MEMORANDUM

REVIEW TYPE: Preliminary Plan of Subdivision

PROJECT NAME: Kenilworth – North Chevy Chase

CASE #: 120080300

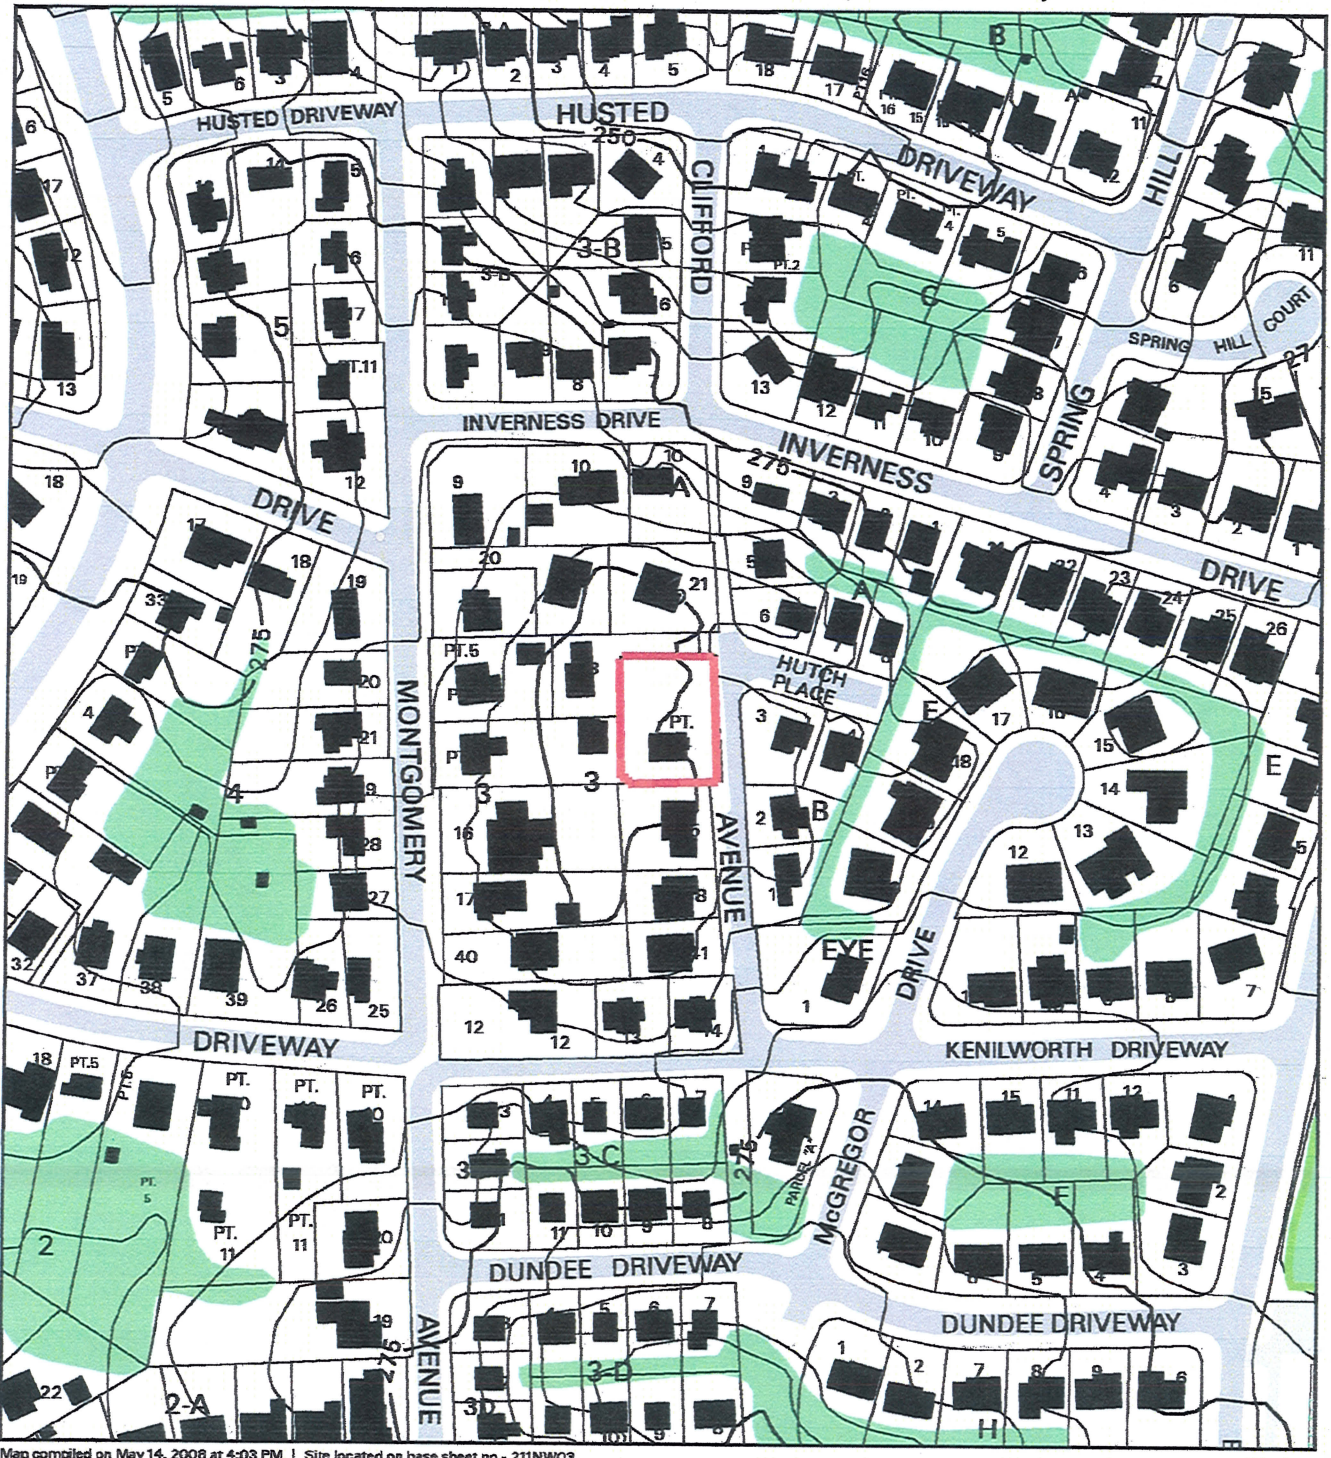
The subject property, shown below and in Attachment A, is a part of a platted lot measuring 15,790 square feet in area. It is within the incorporated Village of North Chevy Chase, on the east side of Clifford Avenue, 410 feet north of Kenilworth Driveway. The zoning on the property is R-60. The property is developed with a one-family dwelling, which is proposed to be retained. Surrounding properties are developed with one-family dwellings in the R-60 zone.

8910 CLIFFORD AVENUE
PROP. LOTS 42 & 43, BLOCK 3
KENILWORTH, NORTH CHEVY CHASE
NEIGHBORHOOD MAP

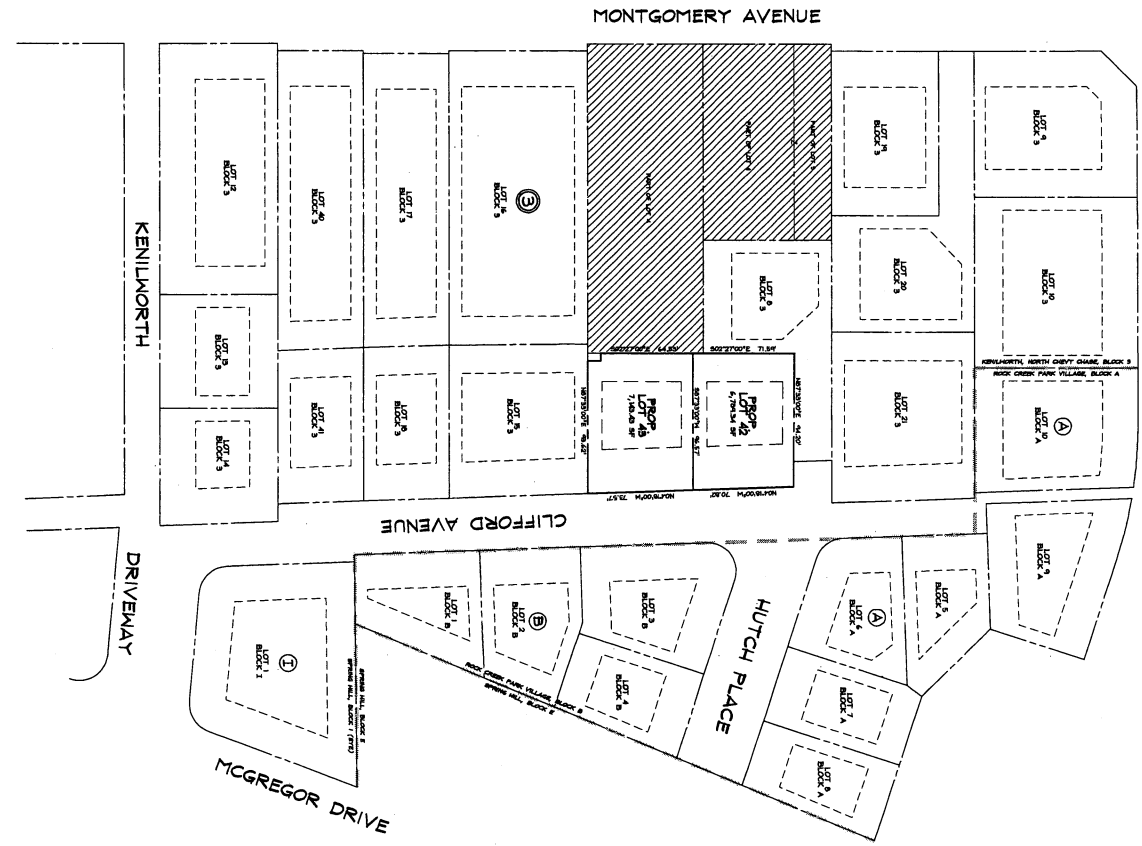
In administering Section 50-29(b)(2) of the Subdivision Regulations, the Planning Board must determine the appropriate “neighborhood” for evaluating the application. In this instance, the Neighborhood selected by the applicant, and agreed to by staff, consists of 26 lots, not including the two proposed lots (Attachment C). The neighborhood includes lots on Clifford Avenue, Hutch Place, and Montgomery Avenue in the R-60 zone. All the lots share multiple access points on these and other streets. The designated neighborhood provides an adequate sample of the lot and development pattern of the area. A tabular summary of the area based on the resubdivision criteria is included in Attachment D.

In a neighborhood of 26 lots, lot frontages range from 25 feet to 177 feet. Four of the lots have frontages of less than 60 feet, fifteen lots have frontages between 60 and 100 feet, and the remaining seven lots have frontages of more than 100 feet. Proposed Lot 42 has a frontage of 71 feet, and proposed Lot 43 has a frontage of 74 feet. **The proposed lots will be of the same character as existing lots in the neighborhood with respect to lot frontage.**

Twenty of the 26 existing lots in the neighborhood are perpendicular in alignment, and the remaining six are corner lots. The two proposed lots are perpendicular in alignment. **The proposed lots are of the same character as existing lots with respect to the alignment criterion.**

The lots in the delineated neighborhood range from 5,203 square feet to 20,031 square feet. Four of the lots are smaller than 6,000 square feet, twelve are between 6,000 and 10,000 square feet, and ten are between 10,000 and 20,031 square feet. Proposed Lot 42 is 6,789 square feet in size and Proposed Lot 43 is 7,143 square feet in size. **The proposed lot sizes are in character with the size of existing lots in the neighborhood.**

Twenty of the existing lots in the neighborhood are rectangular, four are irregularly shaped, and the remaining two are pipestem lots. The two proposed lots are rectangular. **The shapes of the proposed lots will be in character with shapes of the existing lots.**

The lots in the delineated neighborhood range from 52 feet to 177 feet in width. Three of the lots have widths of less than 60 feet, ten lots have widths between 60 and 80 feet, and the remaining thirteen lots have widths of more than 80 feet. Proposed Lot 42 has a width of 71 feet and Proposed Lot 43 has a width of 74 feet. **The proposed lots will be in character with existing lots in the neighborhood with respect to width.**

fourteen are between 2,000 and 5,000 square feet, and seven are between 5,000 and 12,785 square feet. Proposed Lot 42 has a buildable area of 2,397 square feet and Proposed Lot 29 has a buildable area of 2,630 square feet. **The proposed lots will be of the same character as other lots in the neighborhood with respect to buildable area.**
